**Coal Combustion Waste Impoundment
Round 7 - Dam Assessment Report**

Ottumwa Generating Station (Site 012)

Fly Ash Impoundment Dikes

October 2010

Figure 5.5.1-2: Main Ash Pond Primary Spillway Structure Inflow Gate Control Lift

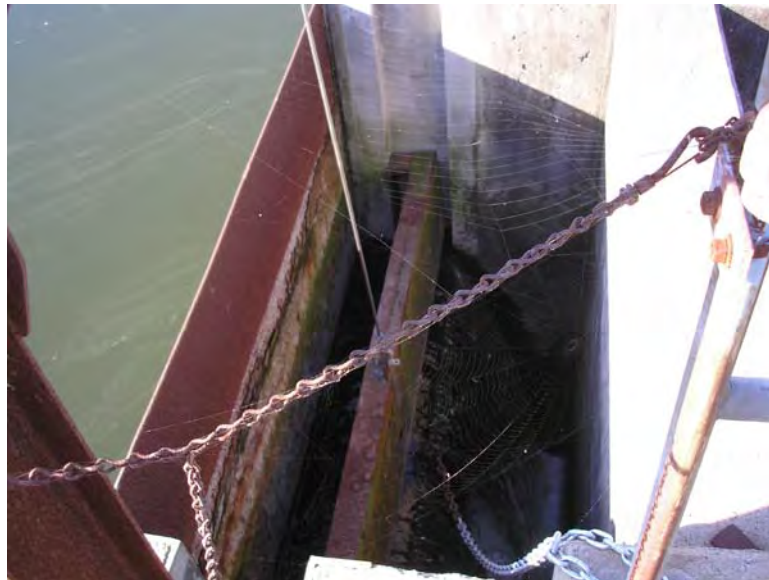
Flow into the spillway riser is controlled by lifting the entry gate to the desired elevation. Figure 5.5.1-2 shows the lift structure used to control the elevation of the spillway riser inflow gate.
